# MEMORANDUM

To: Salt Lake City Historic Landmark Commission  
From: Kelsey Lindquist (385) 226-7227  
Date: April 28, 2022  
Re: Union Pacific Railroad Station Hotel Building & Major Addition PLNHLC2018-00616

This memorandum provides updated information on the proposed Union Pacific Railroad Station Hotel Building and Major Alteration. This proposal was approved by the Historic Landmark Commission on May 2<sup>nd</sup>, 2019. Since the approval, the applicant has worked with staff to satisfy the imposed conditions by the Historic Landmark Commission. The applicant subsequently submitted building permits to Building Services for a core and shell permit. Staff reviewed the building permit submittal and noted several discrepancies between the approved plans and the building permit plans. The applicant identified the changes to the approval and staff determined that the **requested changes are beyond staff's discretion**, and therefore the revisions are being forwarded to the commission for a decision.

Revised Western Elevation

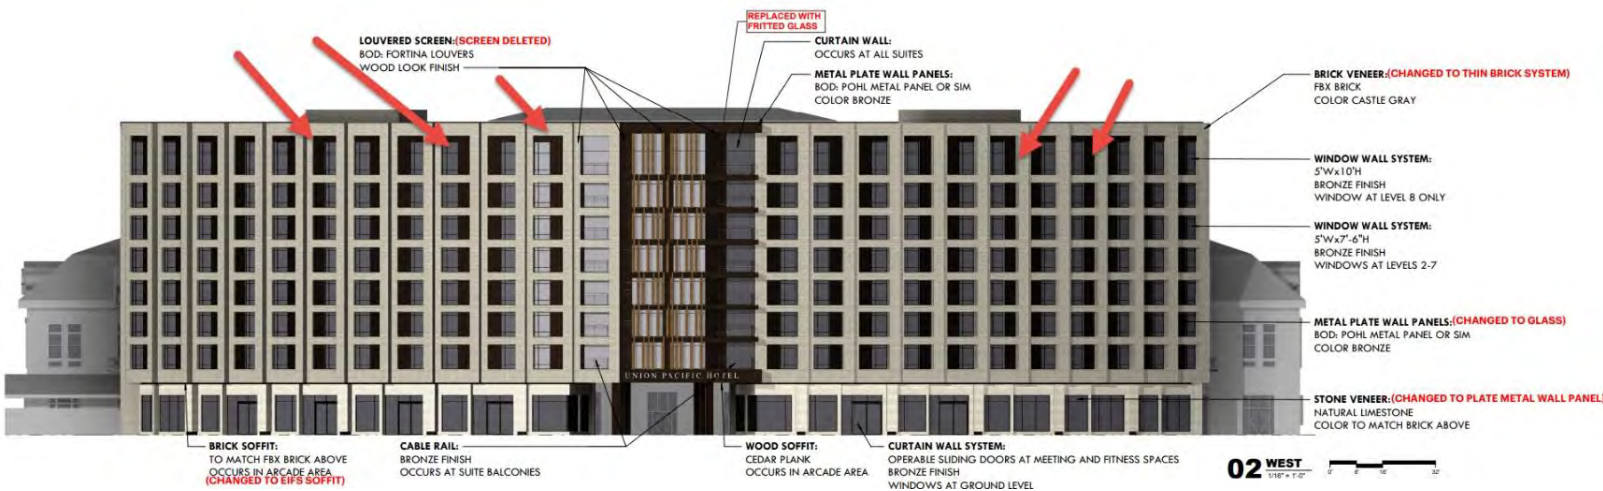
### Western Elevation Material Modification

The approved design consisted of deep angled recesses that contained both fenestration and metal paneling. The combination of the two created a unique visual shadow effect. The applicant is seeking to remove the approved metal paneling from the fenestration recess and replace with this material with glass panels.

Approved Western Elevation

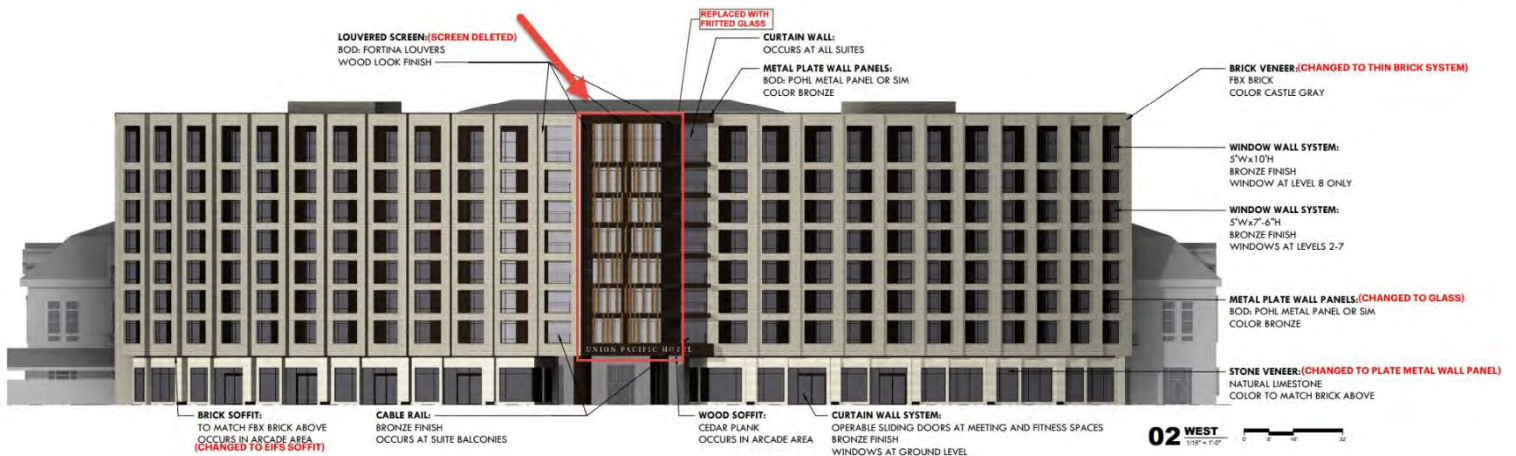
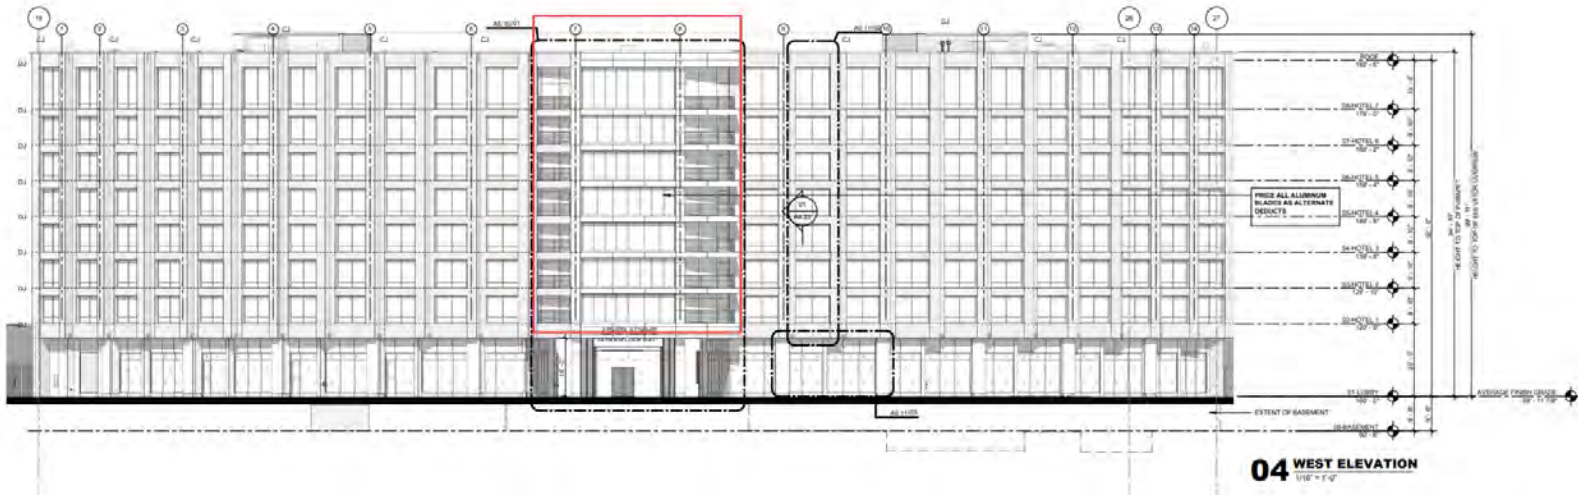
### Western Elevation Screen Elimination

The approved design contained a fin screening system located on the center of the western elevation. The applicant is seeking to remove the screen system from the western elevation and provide exposed windows and balcony features.

### Western Soffit Elevation Change

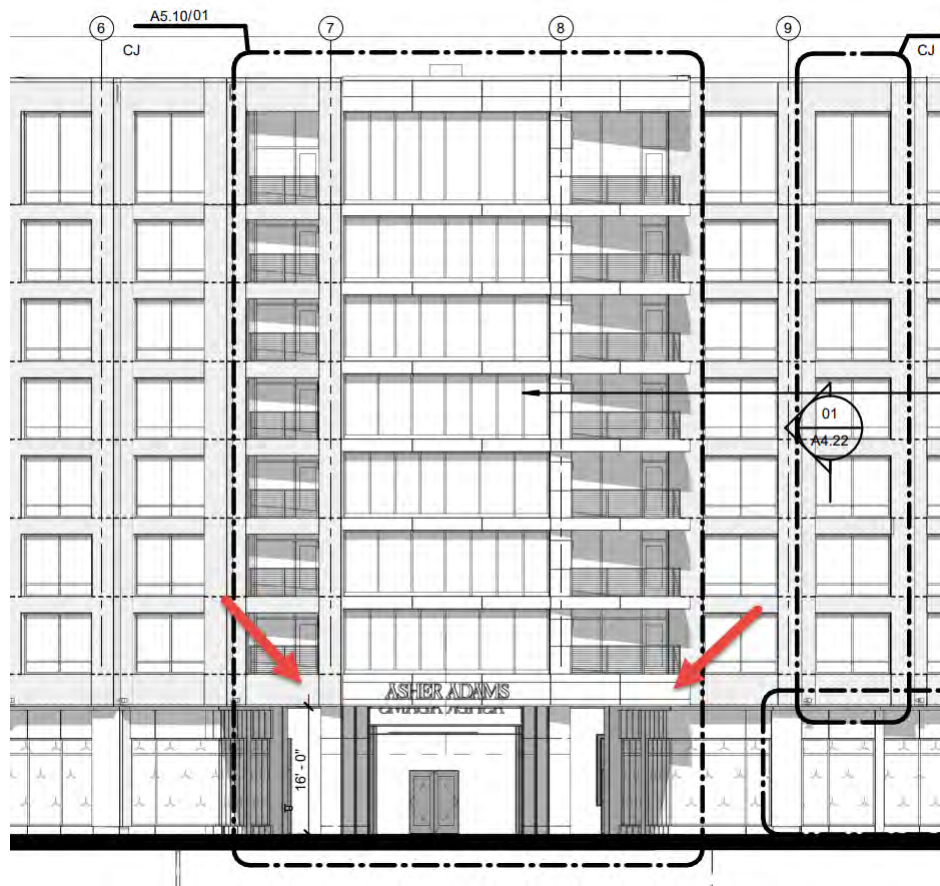
The applicant adjusted the height from the approved approximate 18' feet in ground to soffit height. The new ground to soffit height for the western entry ranges from 16' at the edges to 17'6" in the center.

Approved Eastern Elevation

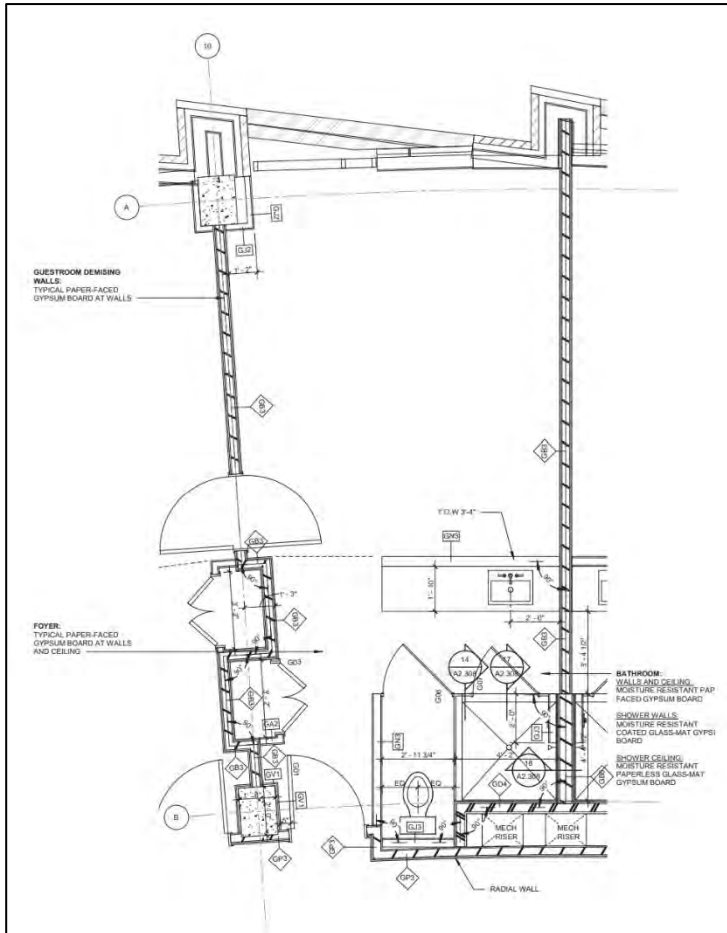
The applicant is requesting to modify the approved metal material to EIFS on the eastern elevation. The metal material was applied to each level in a horizontal band between each building reveal. The proposed EIFS approximates a total 4.3% of the eastern building façade.

The applicant is also seeking approval to adjust the approved window sizes on the eastern elevation, to increase consistency and more variation along the elevation. This elevation is primarily behind the Union Pacific Railroad Station.

## Reduction of Approved Articulation

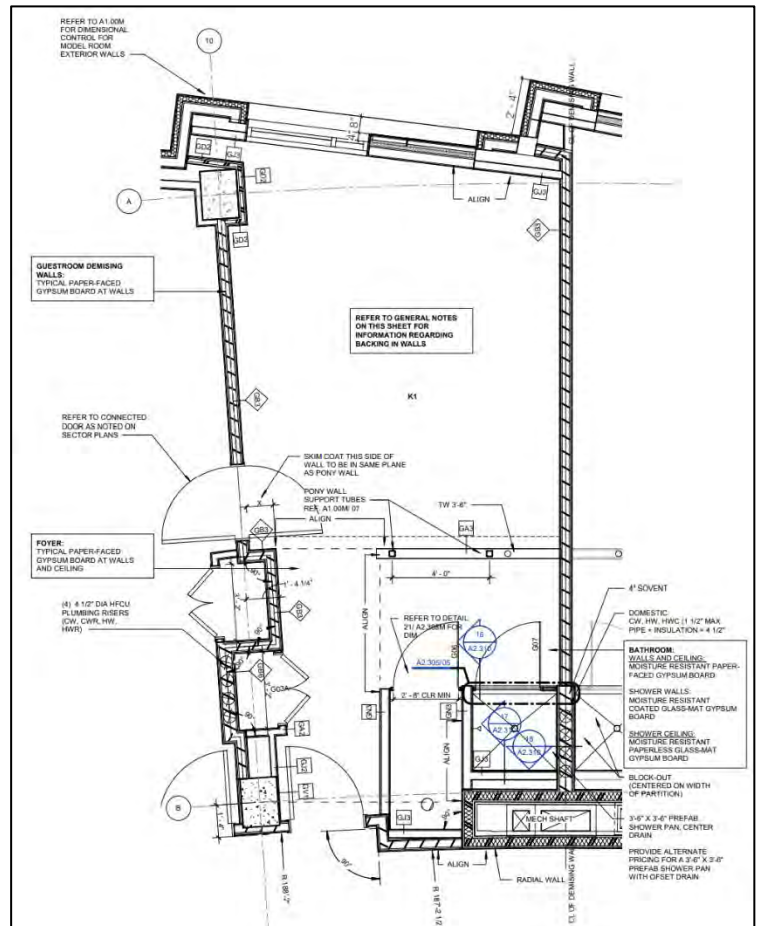
Applicant is seeking approval to reduce the approved dimension of façade articulation. The approved articulation consisted of a sever angle. The revised **dimension is approximately 2'4"**. The change reduces the severity of the angle for each recessed feature. Even with the dimensional and angle reduction, the façade has significant articulation.

### Building Height Increase

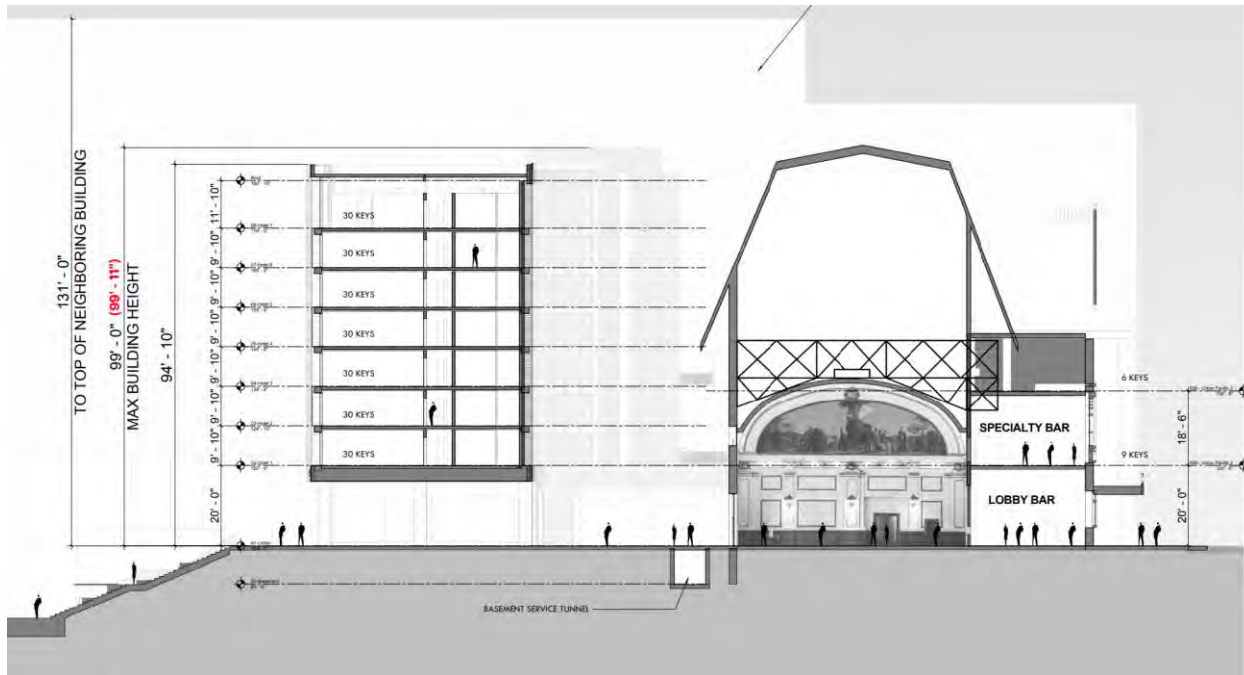
The proposed new construction/major alteration was approved at 99' in height. The current design has a modified height of 99'11".

### Proposed Sign Package

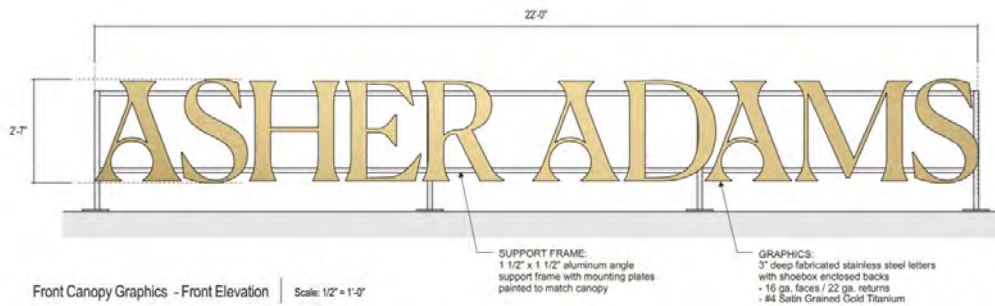
The applicant is proposing a marquee sign approximately 60 square feet in size. The sign will consist of gold stainless steel letters. This marquee sign complies with the limitations for marquee signs.

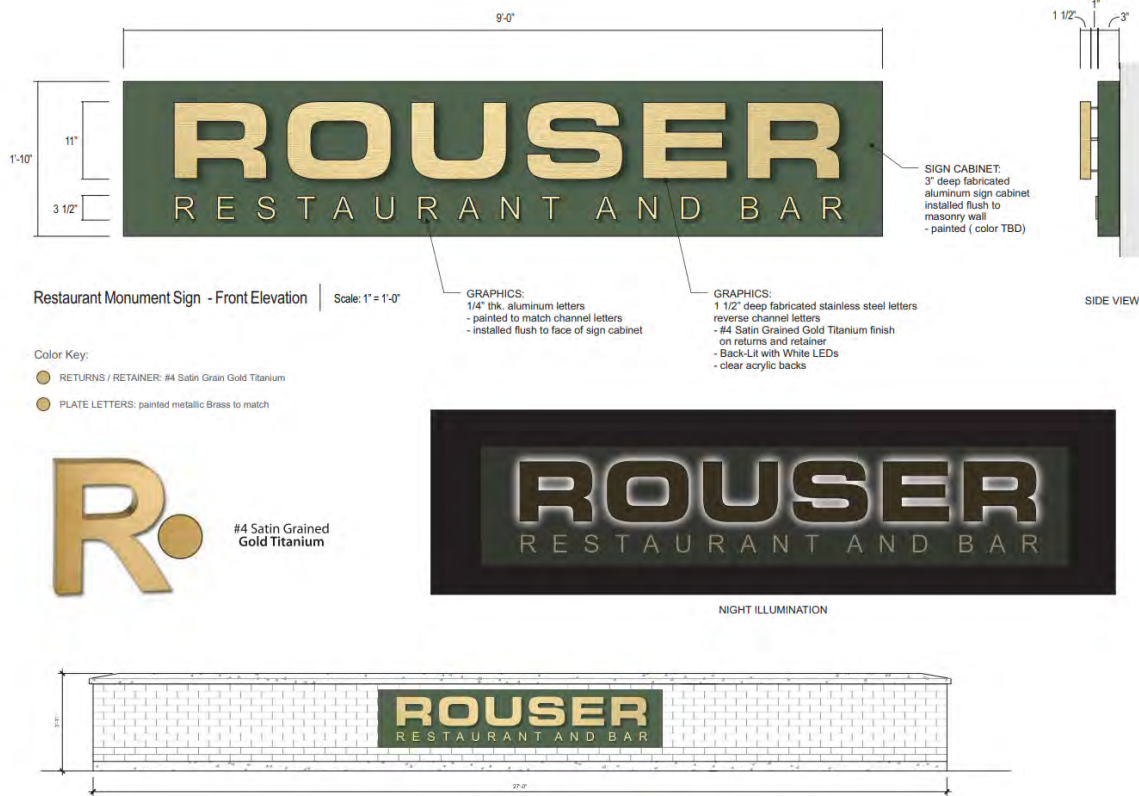
Applicant is also proposing to install a monument sign in front of the southern bay of the Union Pacific Station. The sign consists of a brick wall approximately 3'1" in height and 27' in length. The sign itself is approximately 18 square feet in size. The monument sign complies with the ordinance limitations for monument signs.

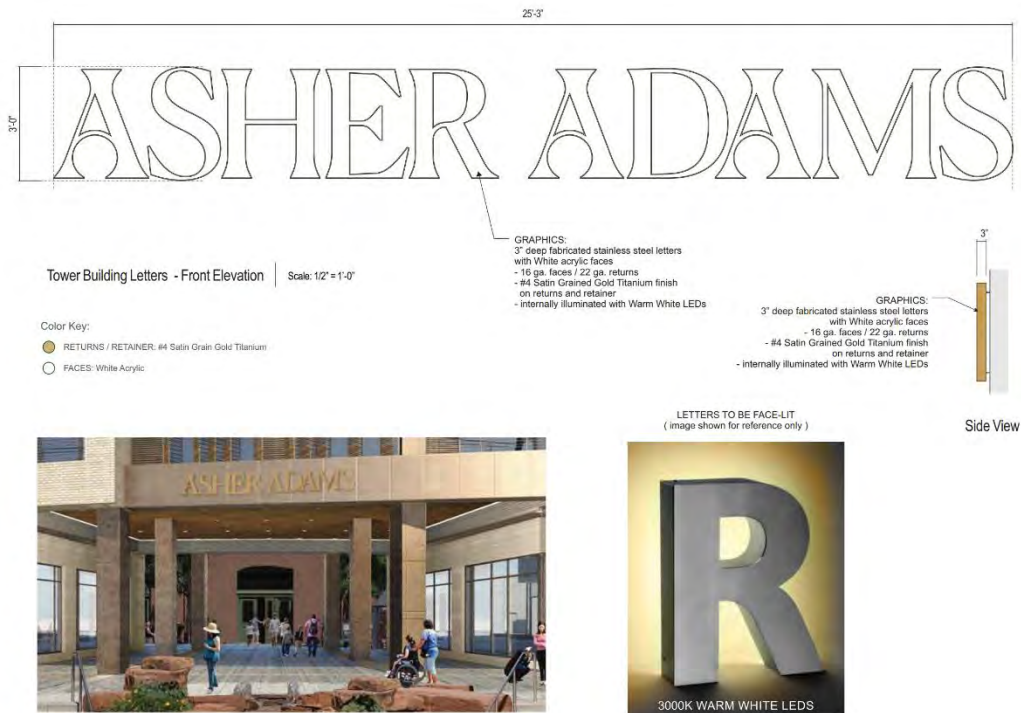
The sign proposal for the western elevation was simplified to one building sign for the hotel. The building sign is approximately 76 square feet in size. The sign is comprised of internally illuminated stainless steel letters. The sign located on the western elevation faces the interior of the Gateway. The Gateway Master Sign Plan is applicable to this sign. The proposed sign complies with the sign requirements for Gateway.

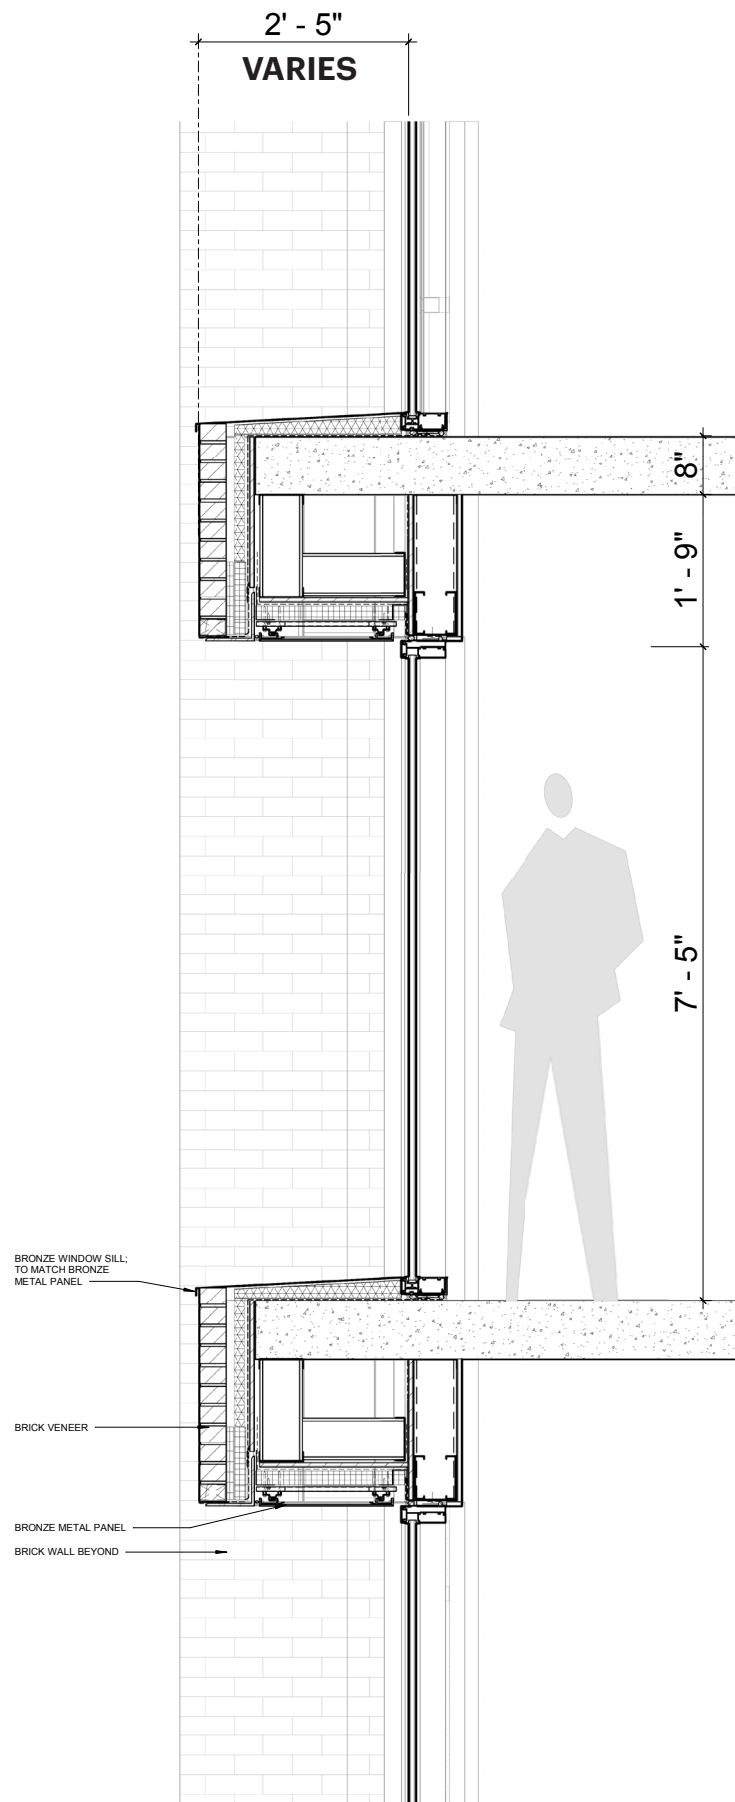
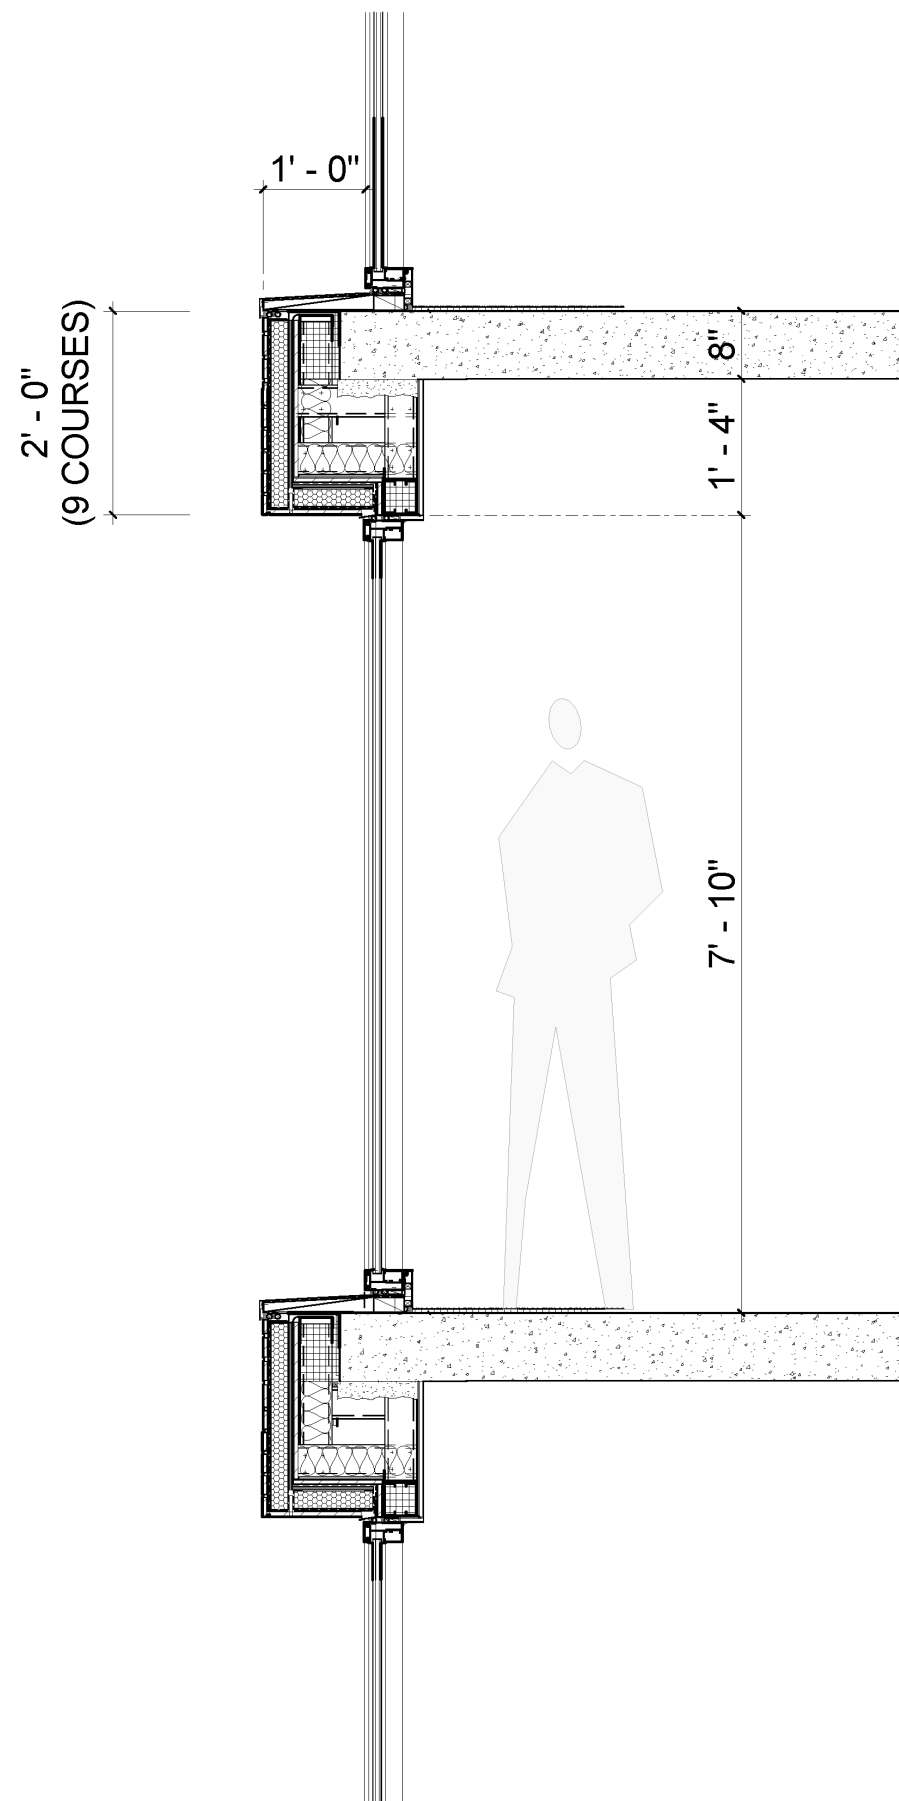
REDUCED RECESS

VARIED WINDOW SIZING
